## Correction of the document GRE/2021/10

This informal document is correction of the official proposal (GRE/2021/10) and the correction is highlighted in yellow.

*Annex 4 - Appendix 1, Figure 1, amend to read:*

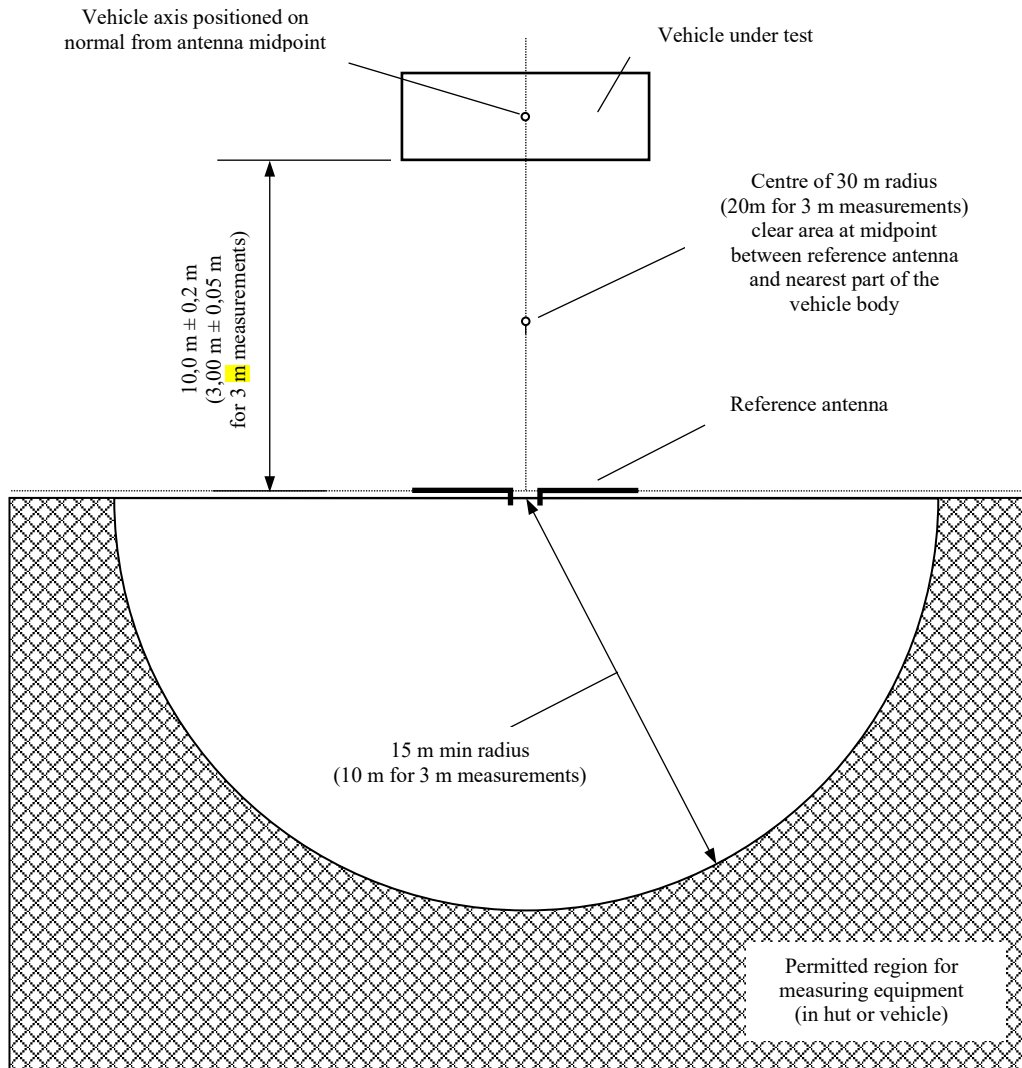
1. There is missing alternative 3 m antenna distance in the Figure 1 of Annex 4 Appendix 1 of the Regulation.

CISPR 12 prescribes alternative 3 m antenna distance in note below the figure: *The 10,0 m ± 0,2 m dimension may be changed to 3,00 m ± 0,05 m in accordance with 5.2.3.2 and 5.2.3.4.* The proposal formally corrects the Figure.

Note: Correction in Figure: "10,0 m ± 0,2 m (**3,00 m ± 0,05 m for 3 m measurements**)"
